PRELIMINARY  
STORMWATER DRAINAGE REPORT  
FOR  
43<sup>rd</sup> AVE MULTI-FAMILY  
701 43<sup>rd</sup> AVE SW  
TPN 4320000160

MAY 2, 2025

Apex Engineering LLC  
2601 South 35th Street, Suite 200  
Tacoma, Washington 98409  
(253) 473-4494  
File #35043-01  
May 2, 2025

# DEVELOPED BASIN MAP

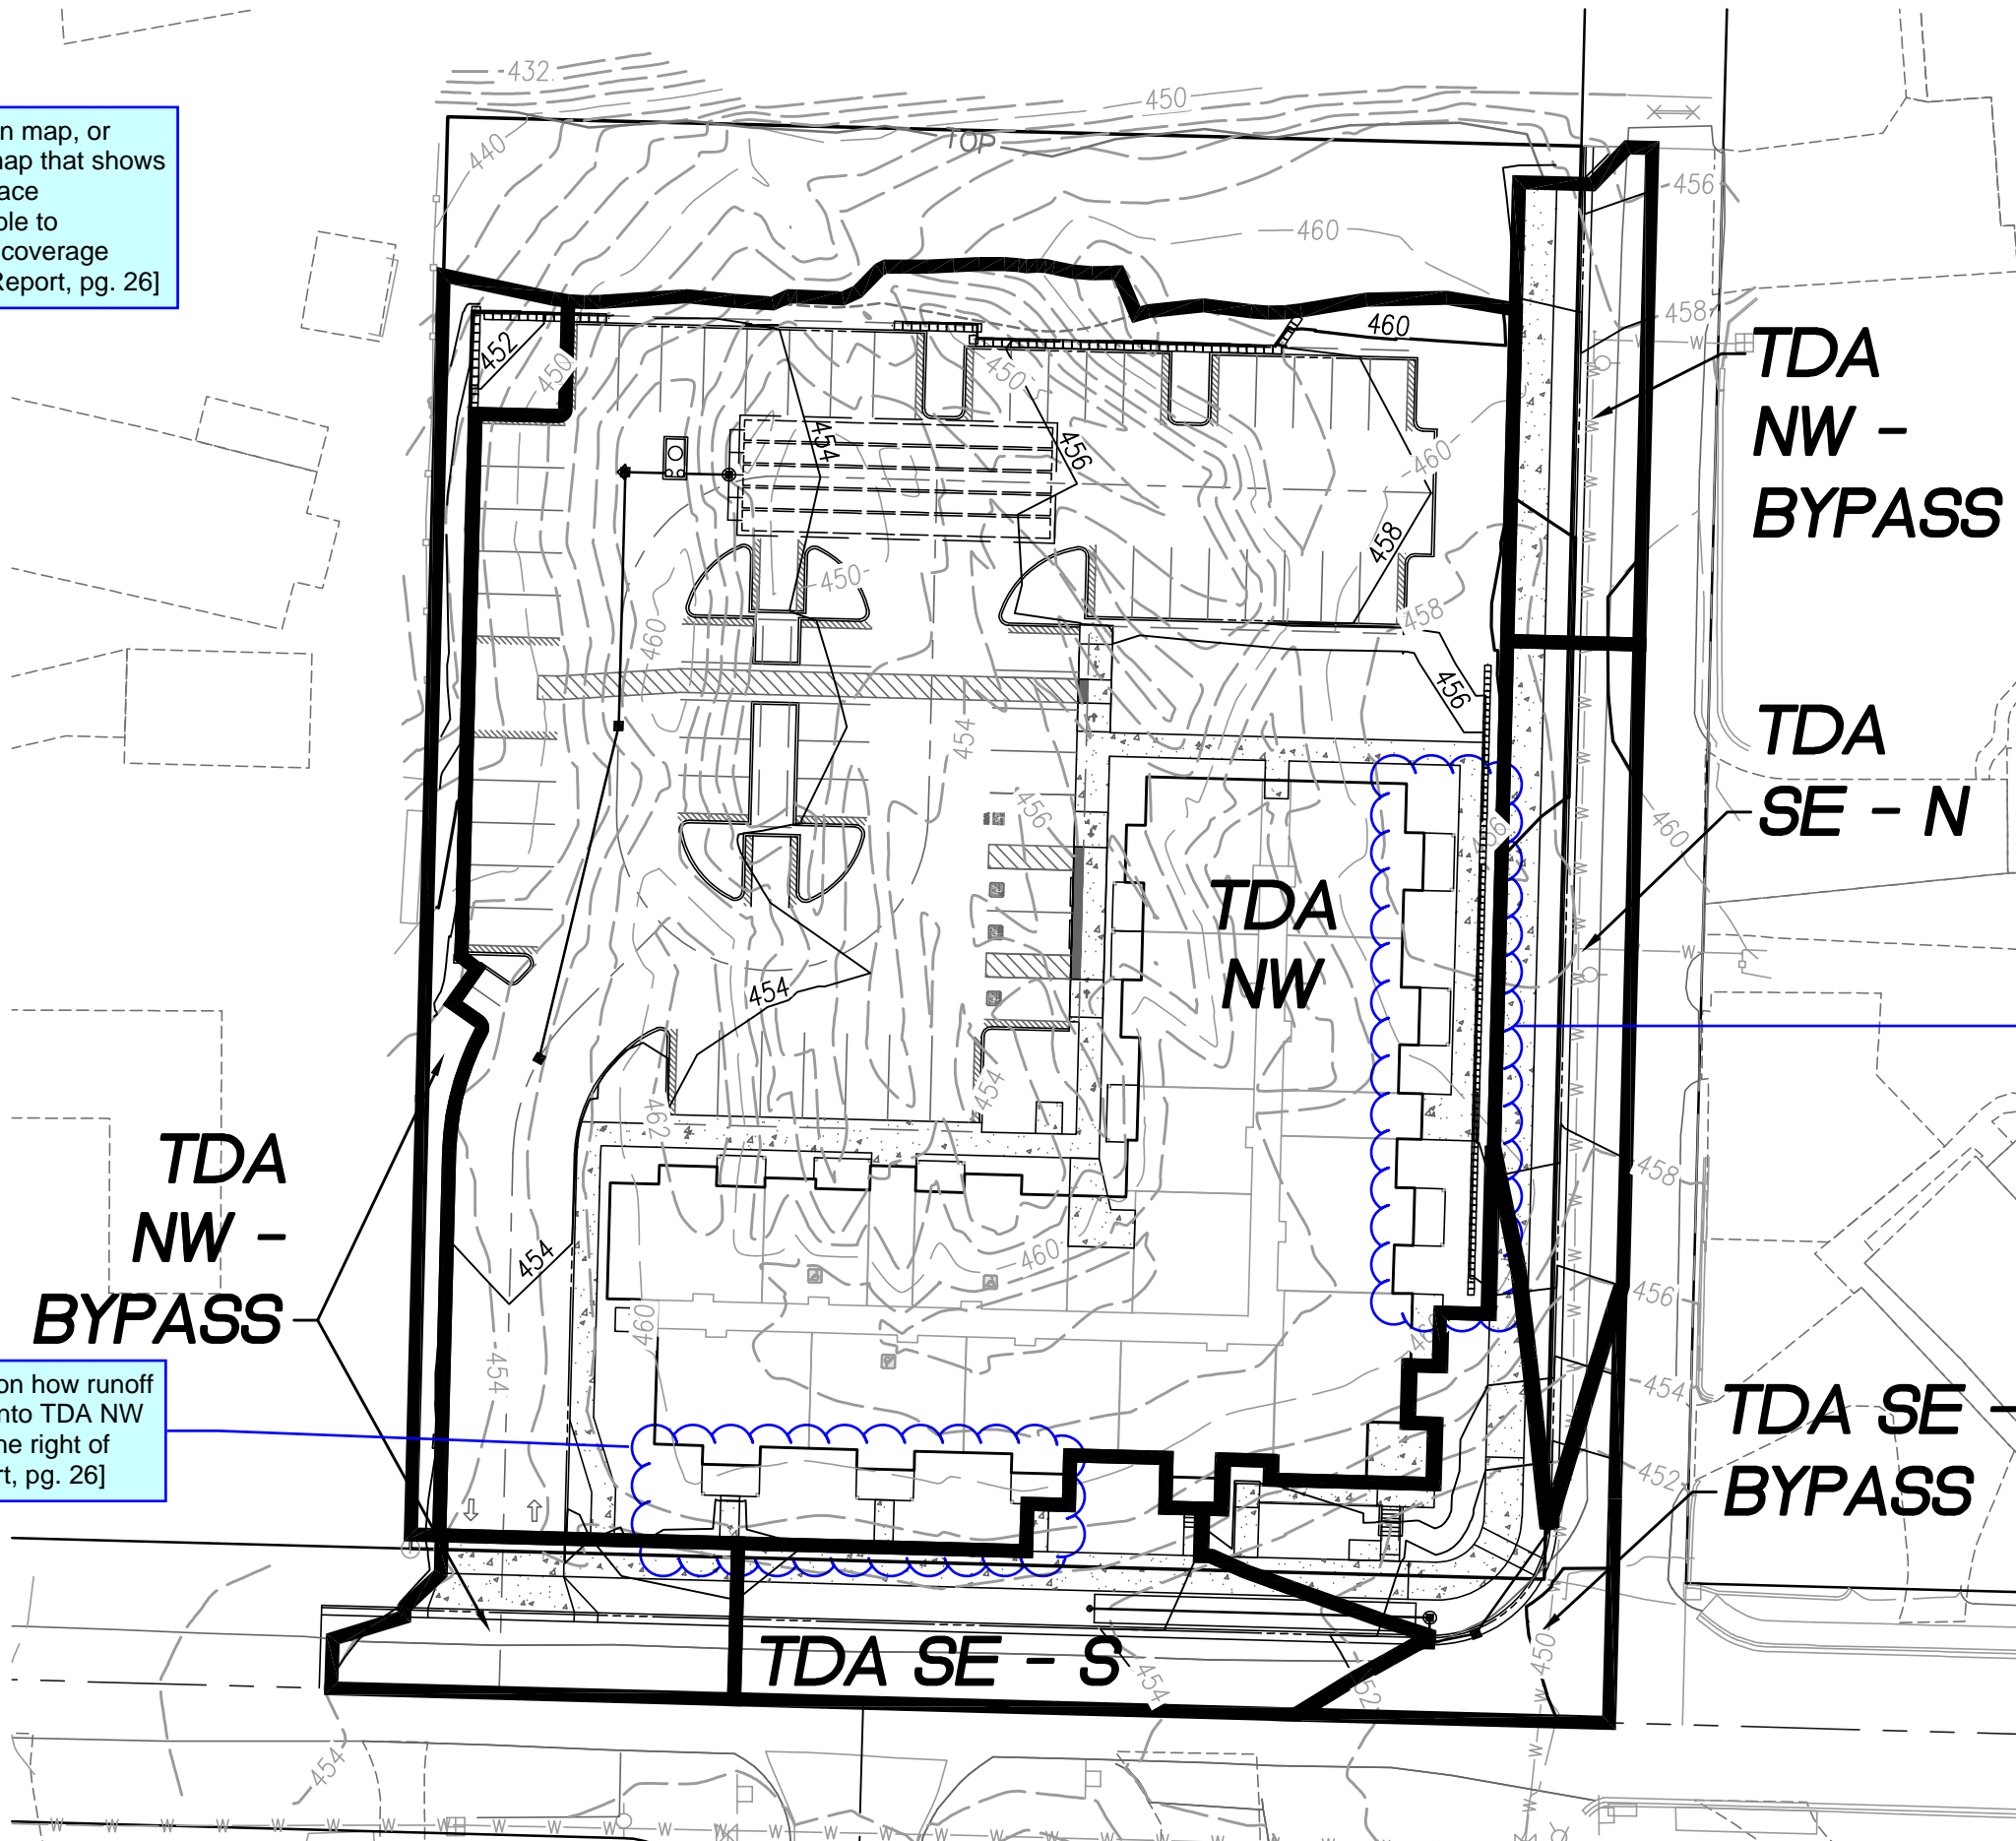
Either show on this basin map, or provide another basin map that shows a breakdown of the surface coverages. Include a table to accompany the surface coverage breakdown. [Drainage Report, pg. 26]

Provide further clarification on how runoff from this area is conveyed into TDA NW rather than flowing toward the right of way TDAs. [Drainage Report, pg. 26]

Provide further clarification on how runoff from this area is conveyed into TDA NW rather than flowing toward the right of way TDAs. [Drainage Report, pg. 26]
